**MASTER DEVELOPMENT DRAINAGE PLAN FOR
AUTUMN HILLS (NE4 SEC 36-12-65) SKETCH PLAN
EL PASO COUNTY, COLORADO**

Due to the review comments
provided, additional new comments
may be generated on the
subsequent submittal

TNE Job No. 2199.13
County Job No. #####

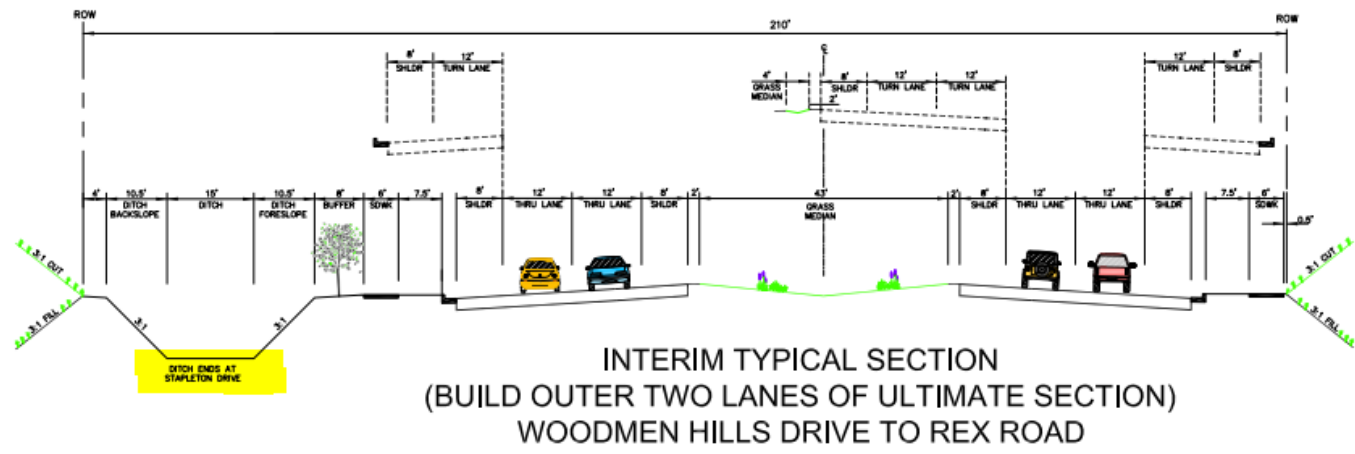
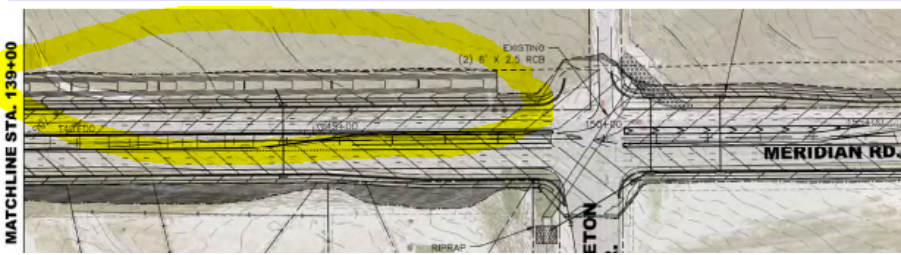
The Meridian Corridor Plan (see link and snippet below) identifies a 15' bottom wide trapezoidal channel along Meridian road that is to convey 167cfs. Please provide analysis/discussion regarding this and indicate whether this channel will still be required. If not required, provide solutions to where Meridian Road runoff will be conveyed to as the corridor plan currently indicates inlets that will convey runoff from the road into the ditch.

JOB NO. 2199.13
 DATE ISSUED 08/01/22
 SHEET NO. 1 OF 2

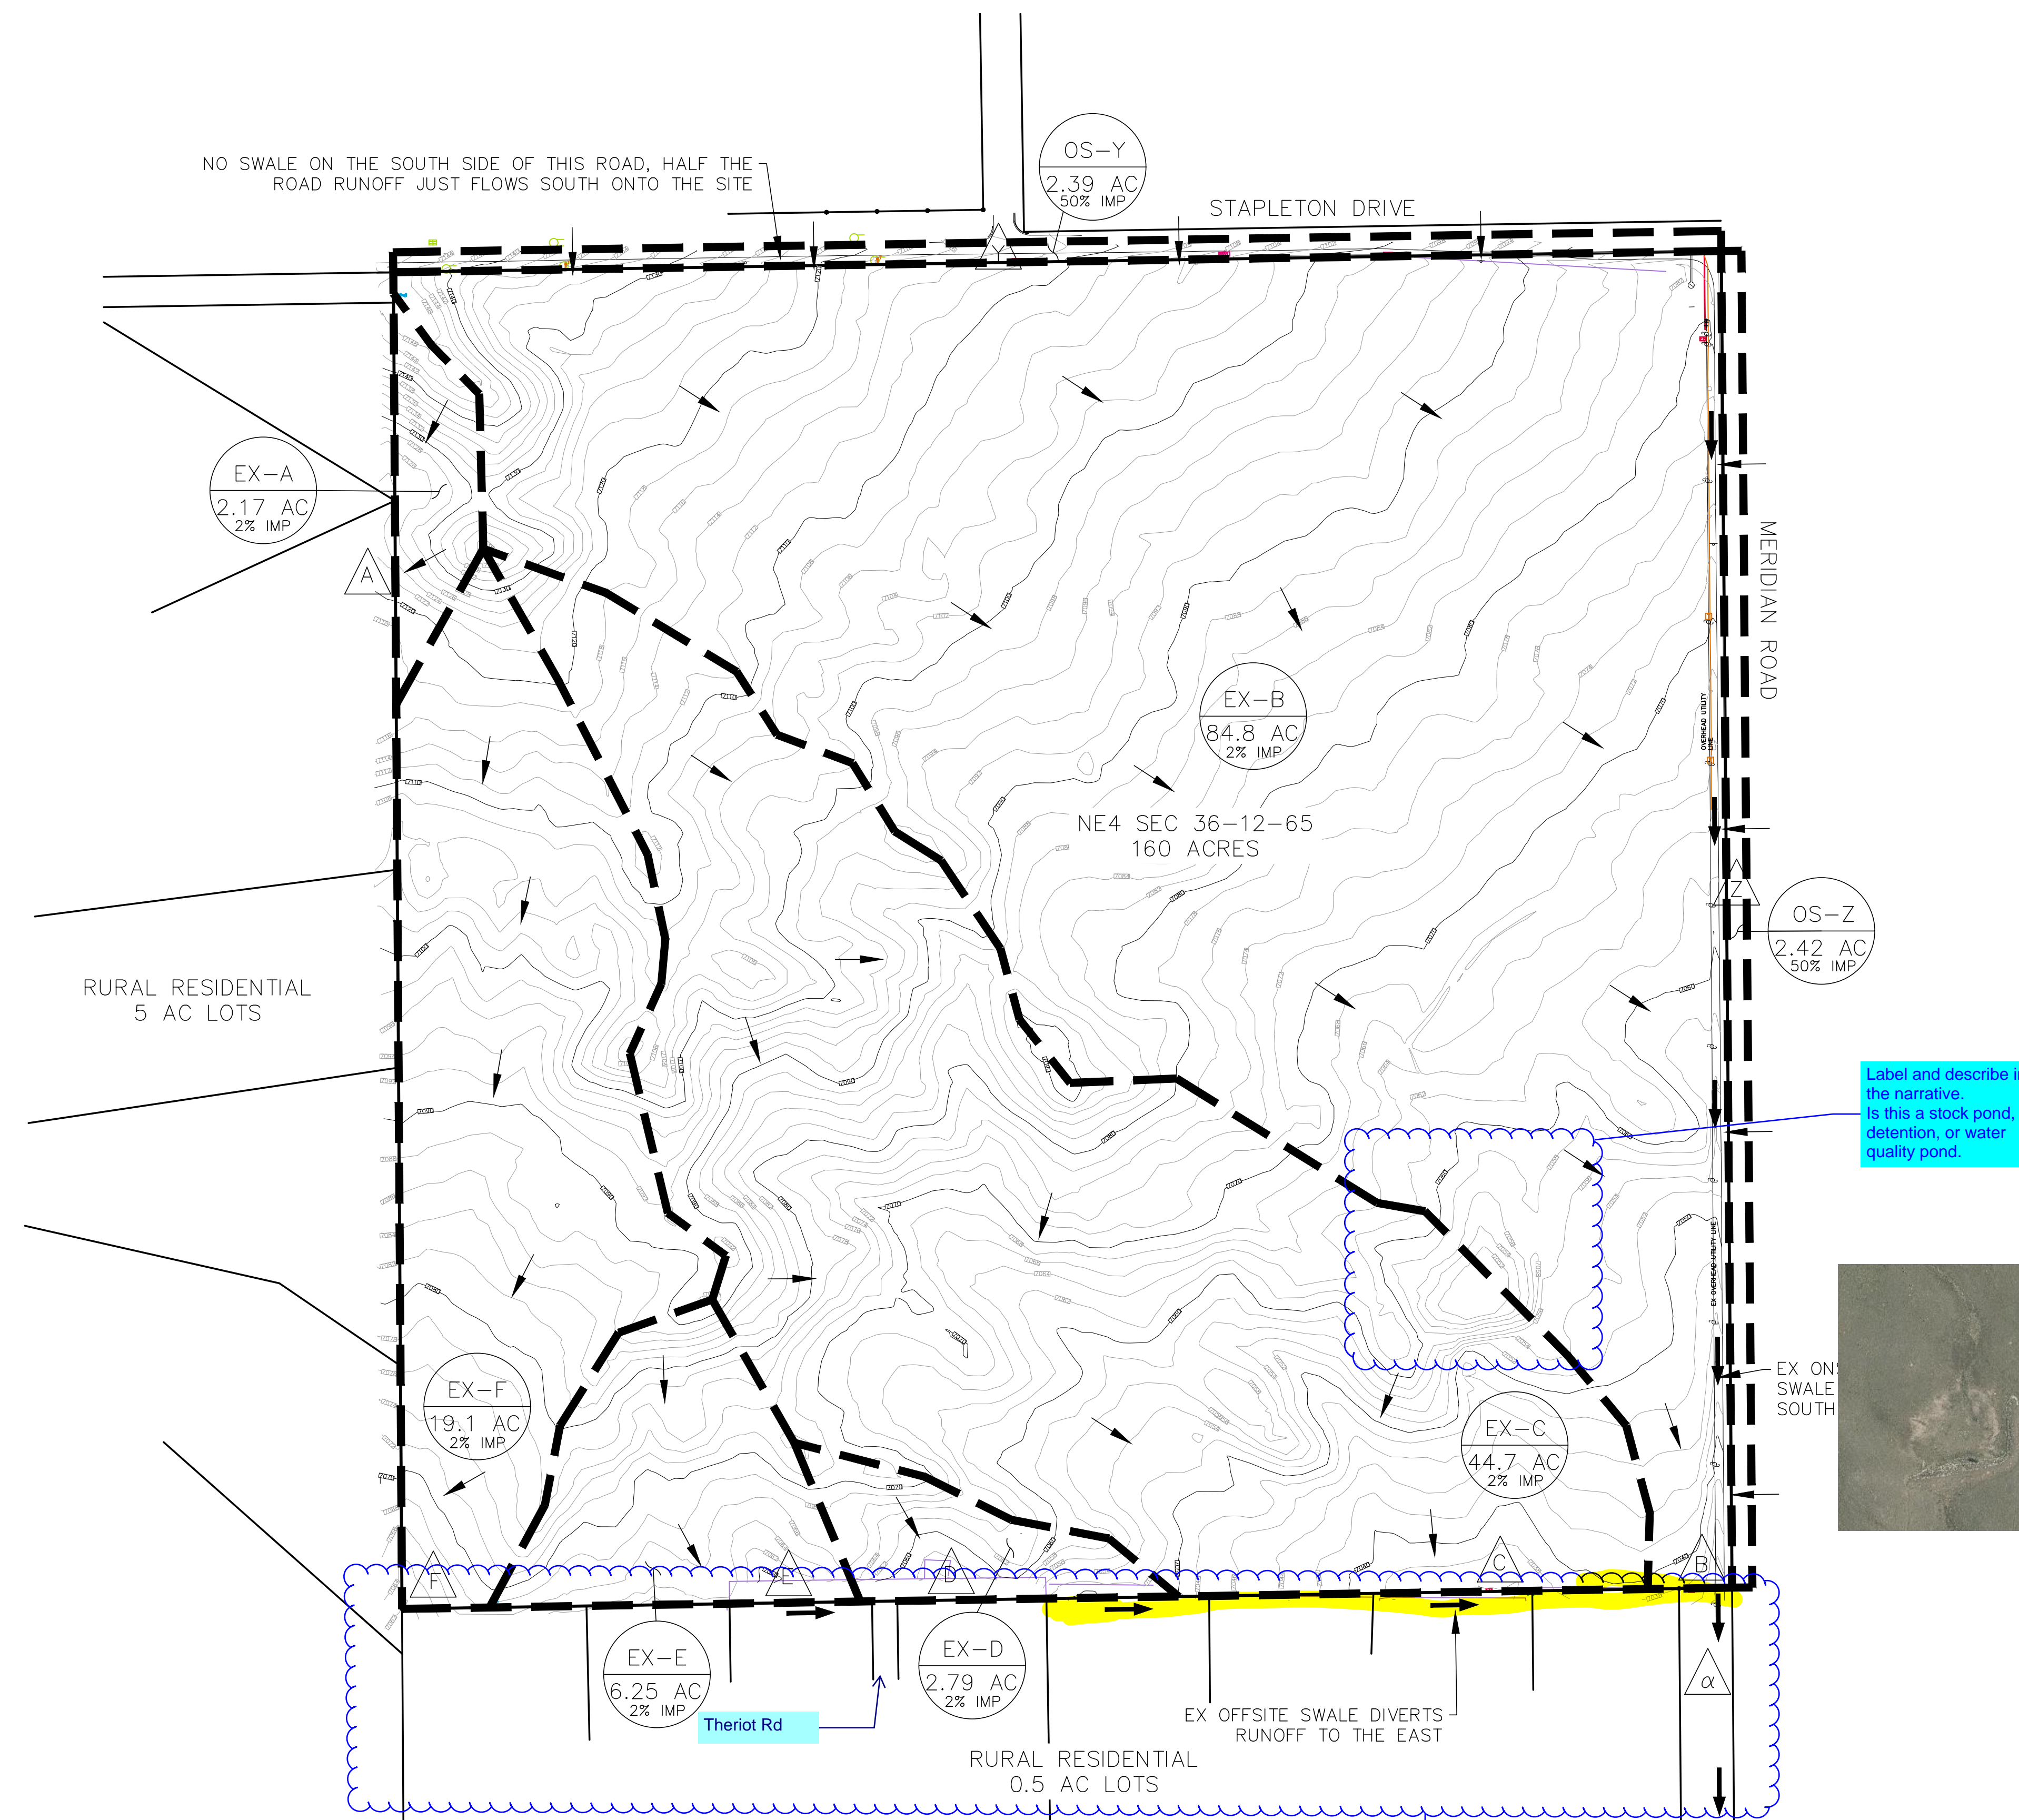
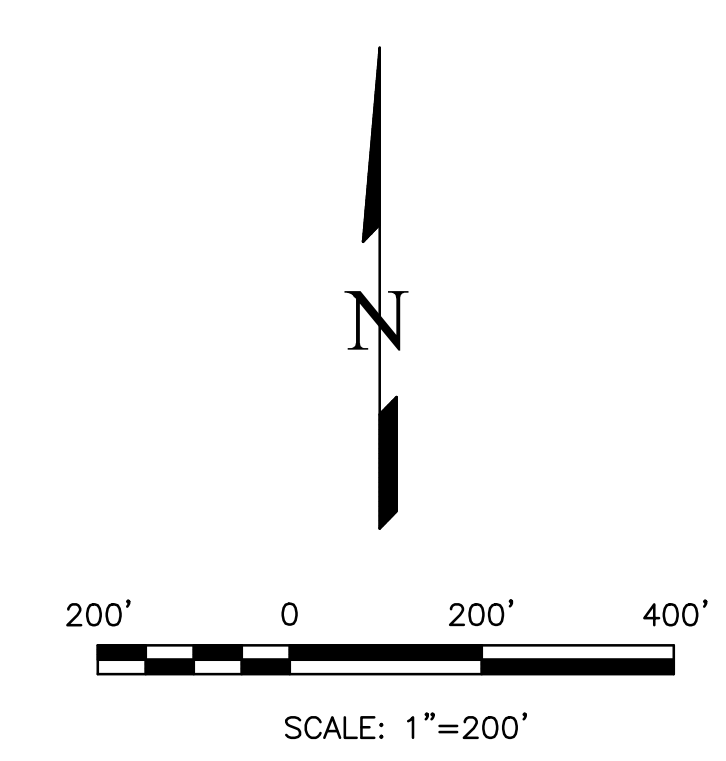
Please extend the contours onsite including the swale that diverts runoff to the east.

Regarding this offsite swale, per woodmen hills subdivision docs, it does not appear that the swale extends to the west past the tank sites on each side of Theriot Rd, therefore DP E may not be conveyed to the east as shown. The easement that contains the swale indicated in Woodmen Hills Filing 4 (PCD File SF97030) only extends along the highlighted residential lots. Woodmen Hills Filing 2 (SF97004) to the west of the highlighted area does not show an easement nor do the CD's show a swale at DP E. Please verify and revise the design as necessary.

DESIGNED BY	DLF
DRAWN BY	DLF
CHECKED BY	LD
H-SCALE	AS NOTED
V-SCALE	AS NOTED
JOB NO.	2199.13
DATE ISSUED	08/01/22
SHEET NO.	2 OF 2

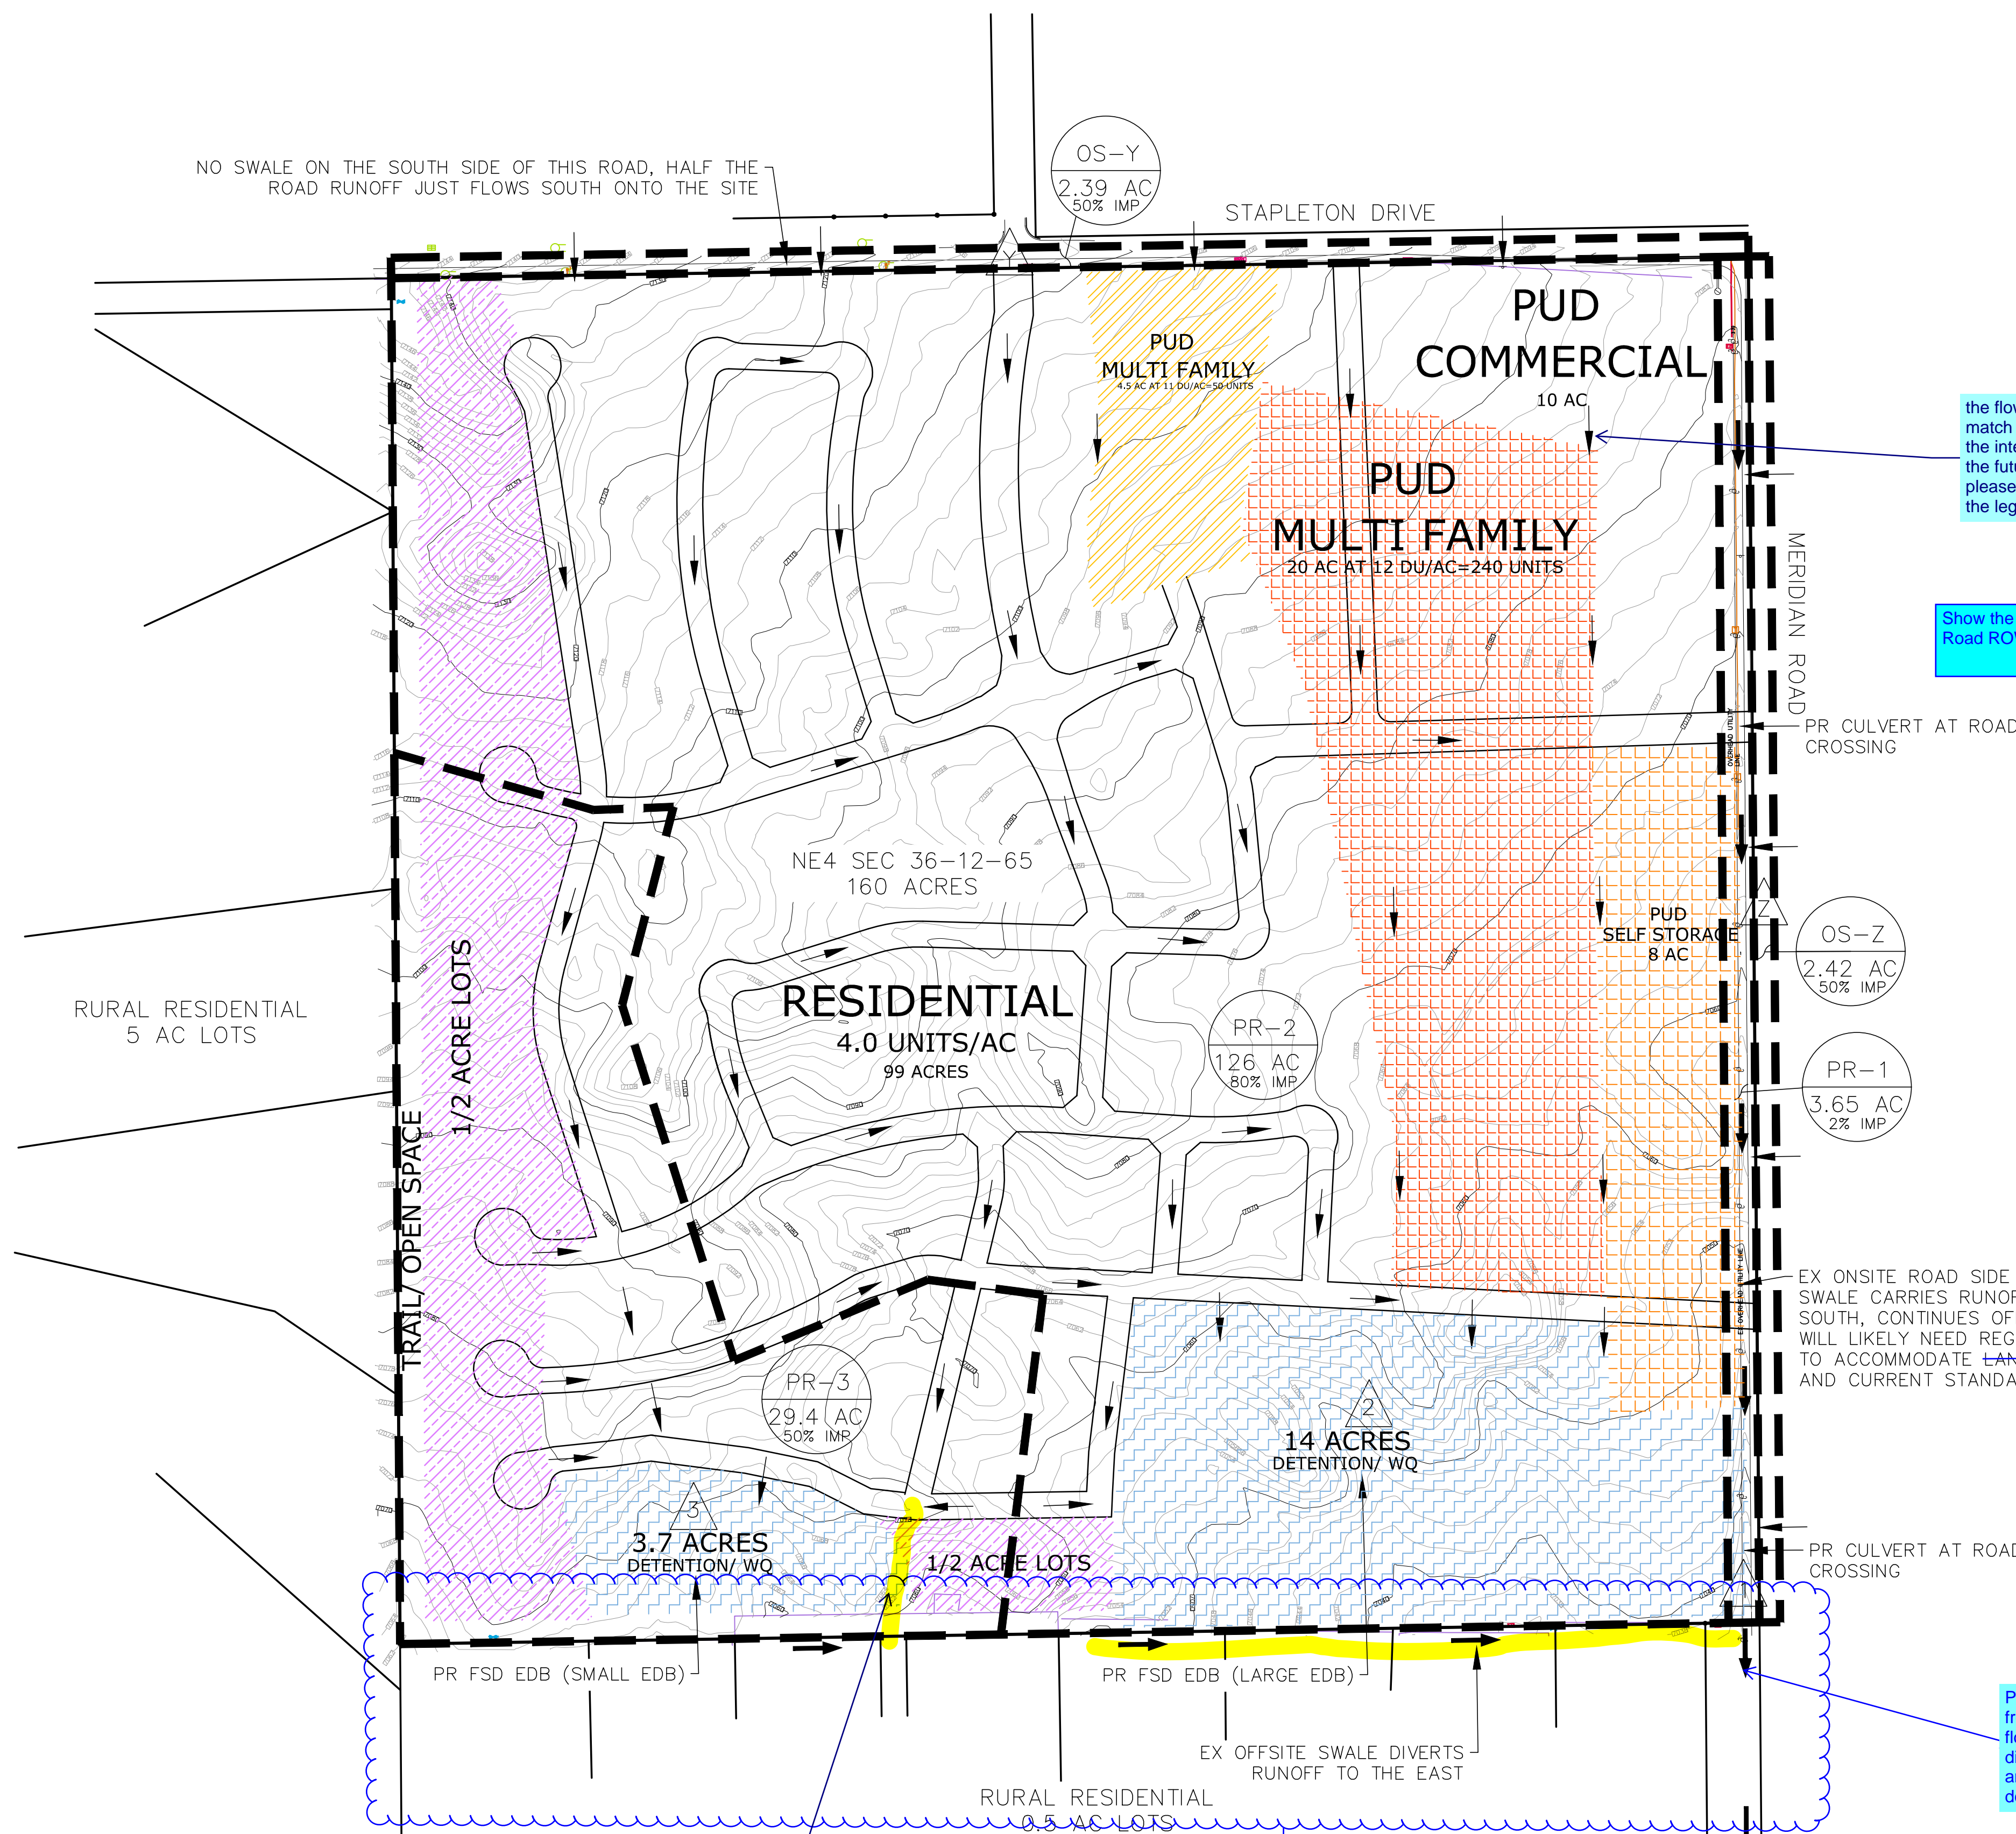
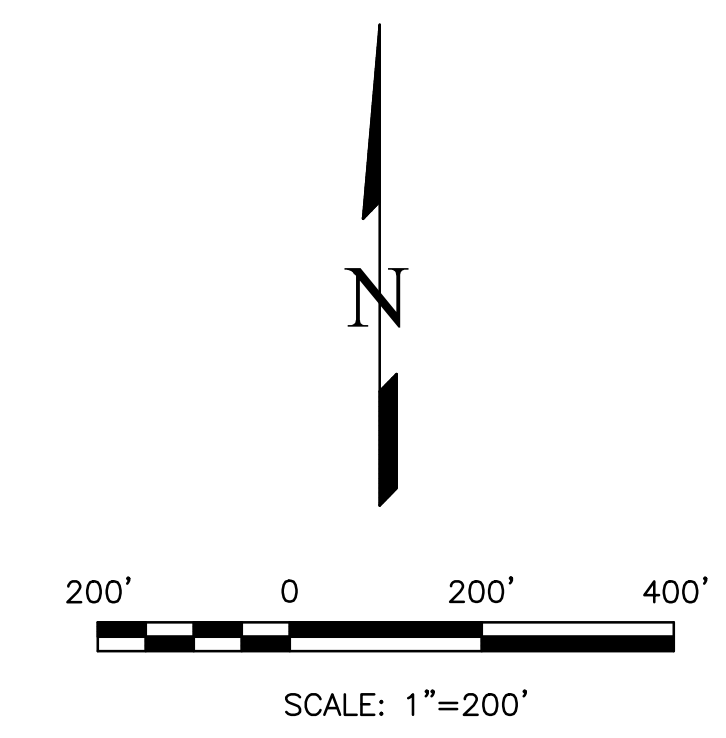
the flow arrows do not match the contours. If the intent is to show the future flow then please clarify that on the legend.

Show the entire Meridian Road ROW

Remove landscaping. Additional ROW will be required for the roadside ditch. Landscaping is not permitted within the ROW & swale.

Provide the ultimate flow rate from the pond and offsite flows conveyed by roadside ditch. Provide discussion and analysis of the downstream ditch.

It's expected that Theriot Rd from the south will be connected to this subdivision. Provide solutions to the problem that arise with the roadway bisecting the swale that conveys flow to the east. Please also see comment on the existing drainage map and address the above comment accordingly per the outfall of this small EDB

Please extend the contours offsite including the swale that diverts runoff to the east. See comment on the existing conditions drainage map and revise accordingly.
